IEEE C802.16e-03/21

From: Changhoi Koo [mailto:chkoo@samsung.com]
Sent: Friday, March 07, 2003 10:57 AM
To: Itzik Kitroser; stds-802-16-mobile@ieee.org
Subject: HO AdHoc document from Samsung

HO mechanism for IEEE 802.16e

Figure 3: Network reference model, Control Plane

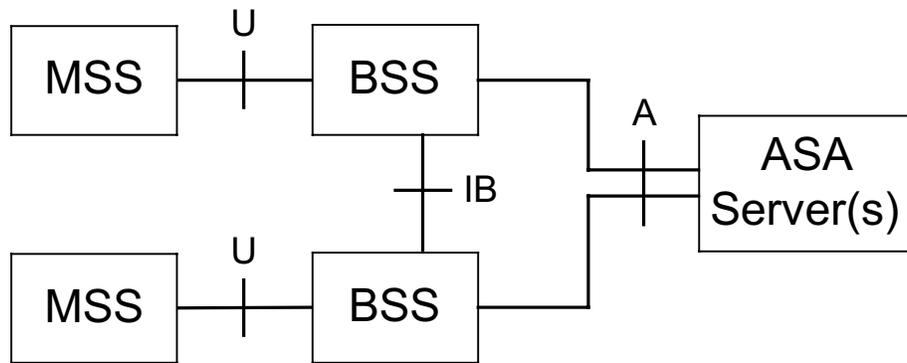
(CHKOO : What does mean “ a single central controller”? I understand one central controller is connected with a set of BSS and control the BSS during HO. Am I right? If I am correct, how to communicate between BSS and BSS. Do they communicate through a central controller?)

(CHKOO : What does mean “cell”? I understand that one BSS is a cell which consists of multiple sectors. Am I right? If I am correct, the definition of BSS surely shall be changed. To make firm inter-cell and intra-cell HO, I figure out the diagram as followings.)

(CHKOO : We need to define the role and figure of Central Controller, and the IB interface between BSS and BSS through Controller.)

Figure 7: HO and initial network entry Figure 8: MSS procedures with HO triggering operation

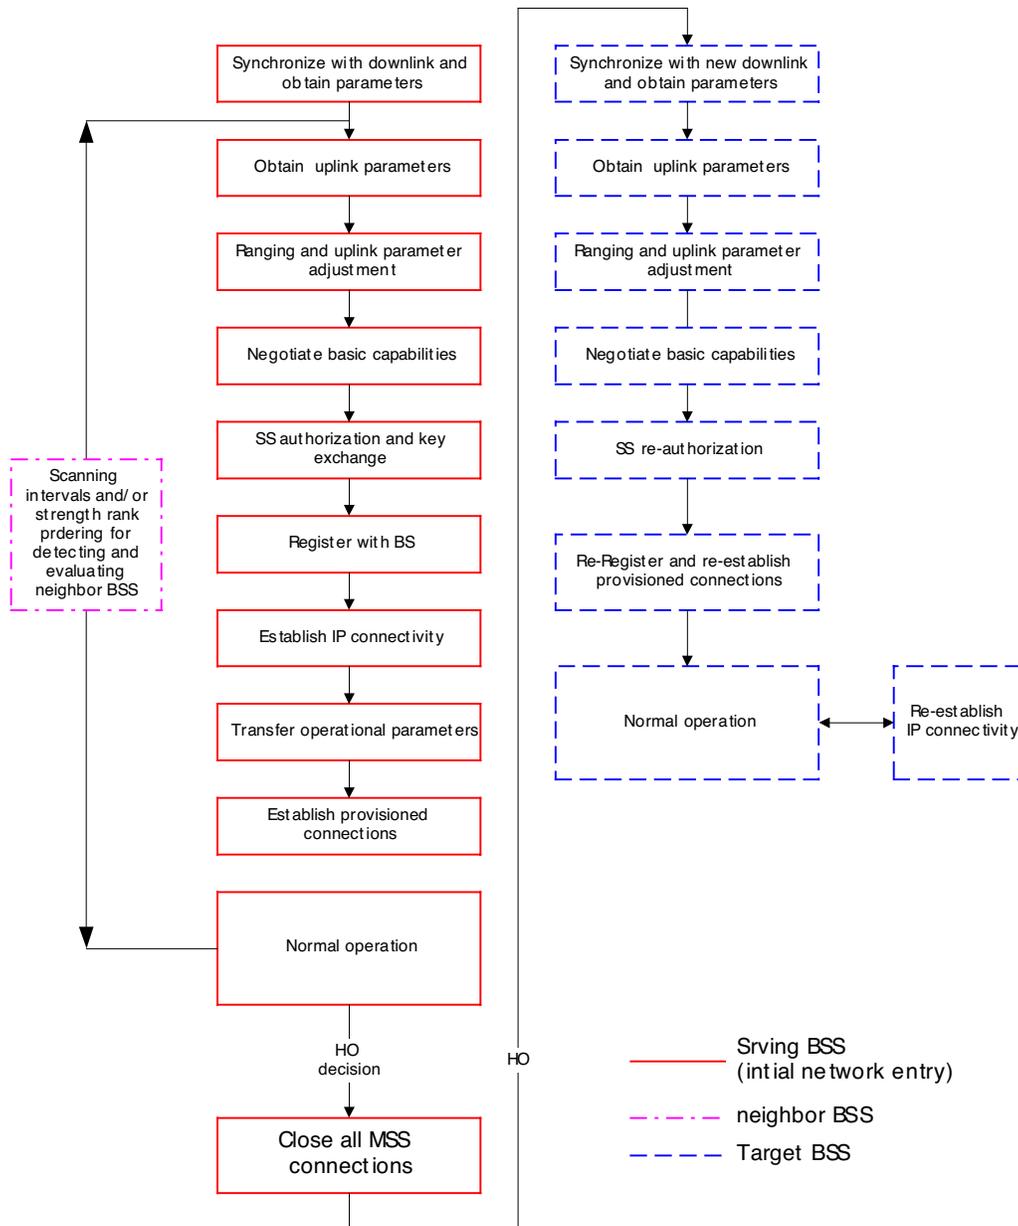
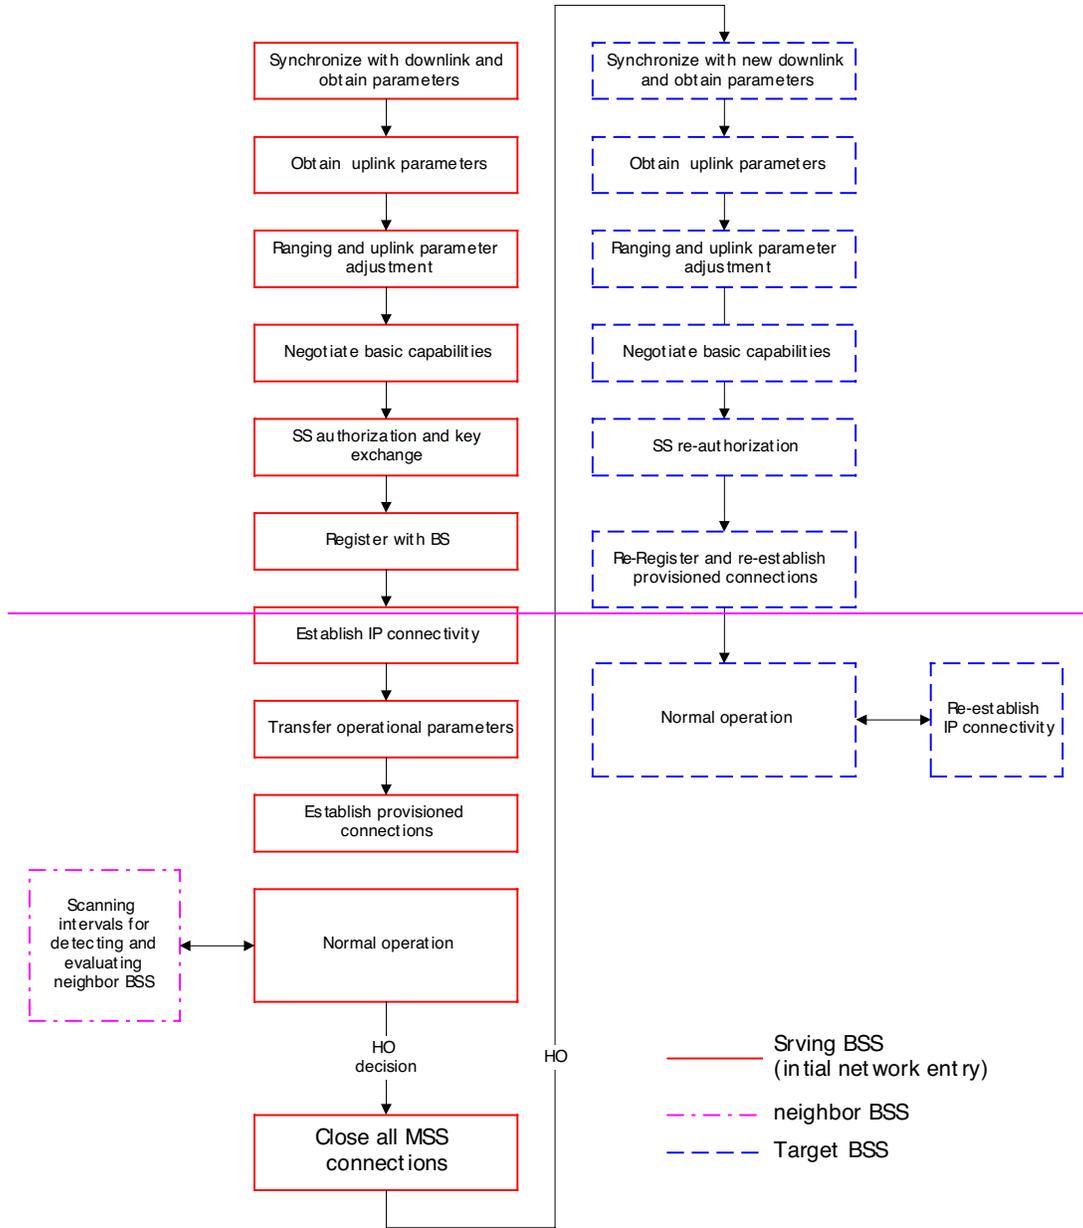
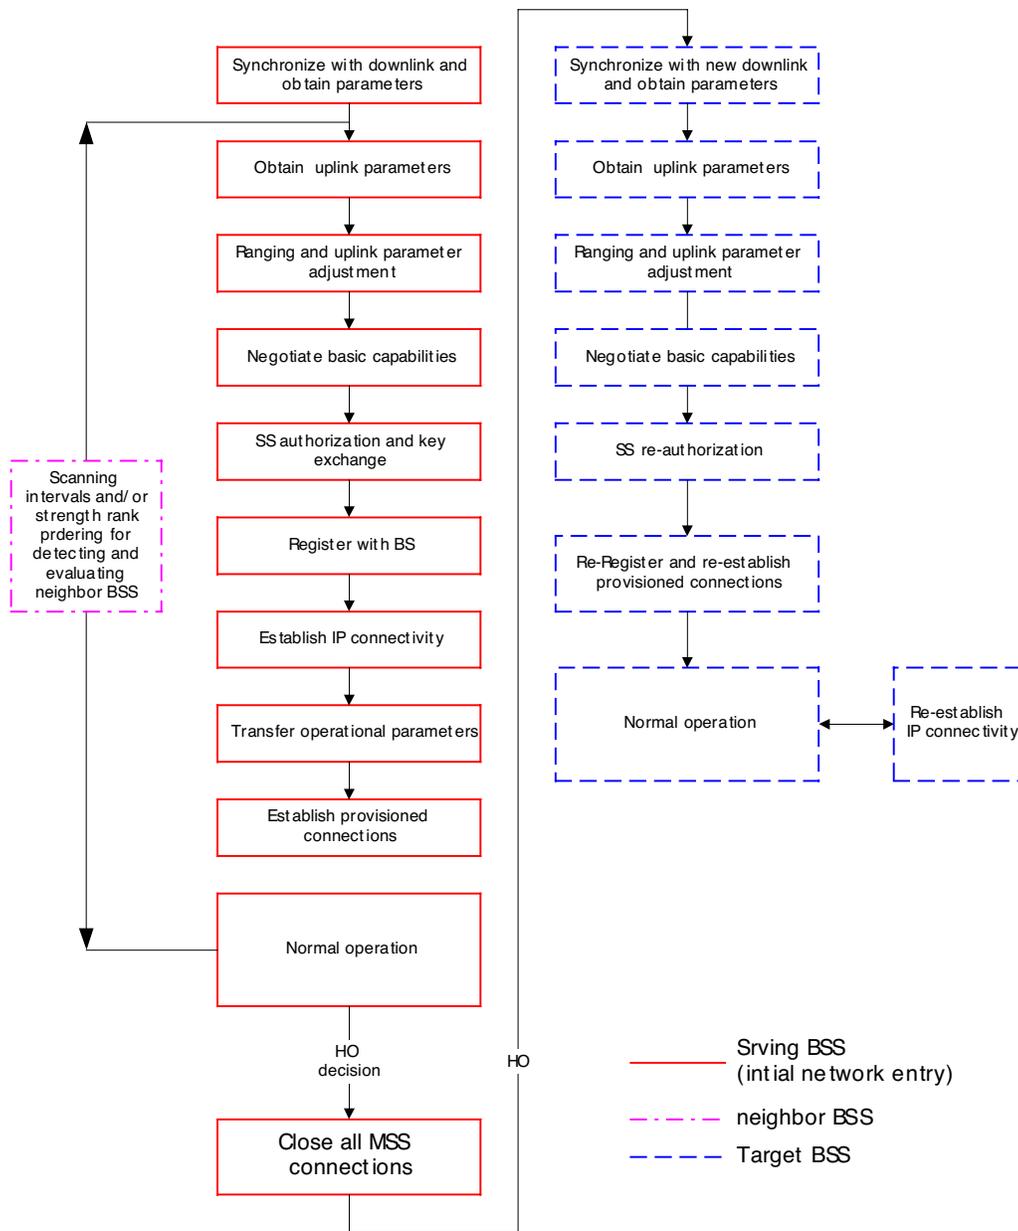
[CHKOO : The HO process is performed during transmitting the user packet data(In-traffic HO on the dedicated channel) and non-transmitting the user packet data(Idle HO on the common channel). Furthermore, those procedures are really different and should be defined separately. In my understanding, the overall HO including points of the Idle and In-traffic HO is depicted in figure 7]

Figure 10: View of a HO process in the time domain

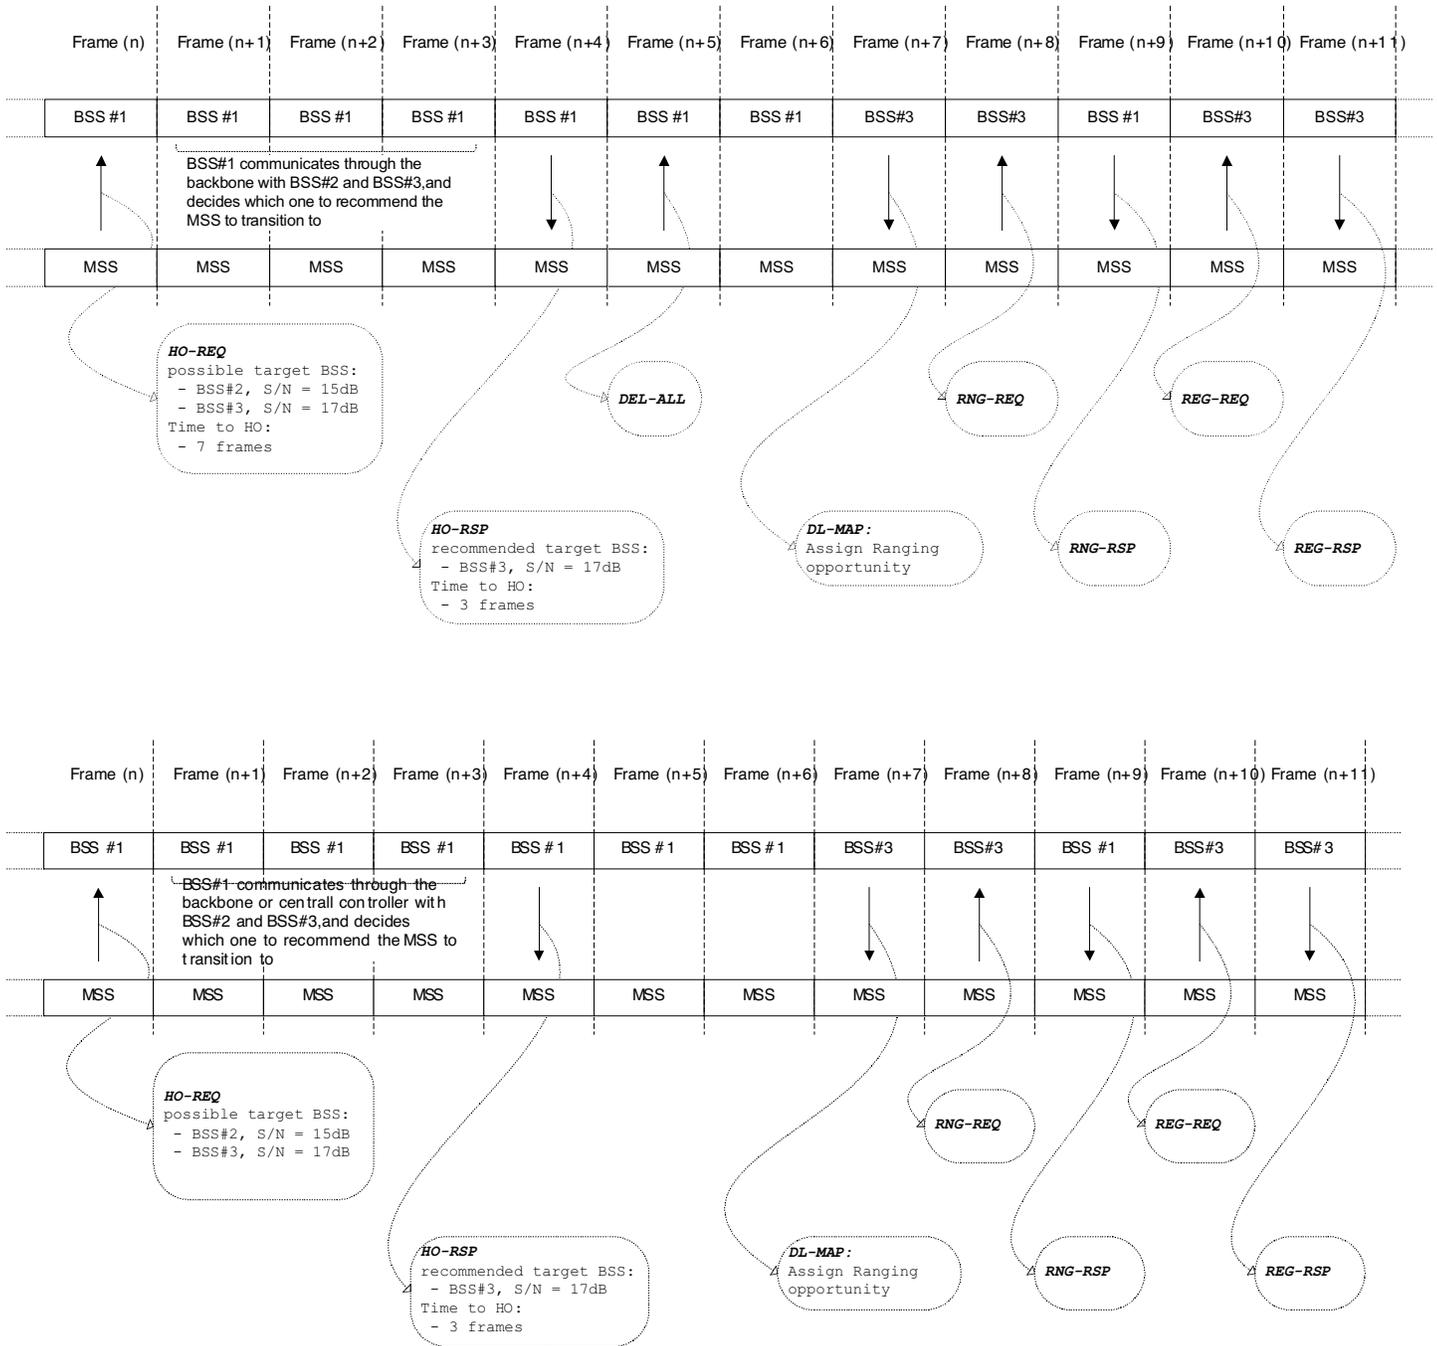
(CHKOO : Estimation time is not required but activation time(time to HO in figure 10) which indicates the actual HO operation to receive the data from the target BSS)
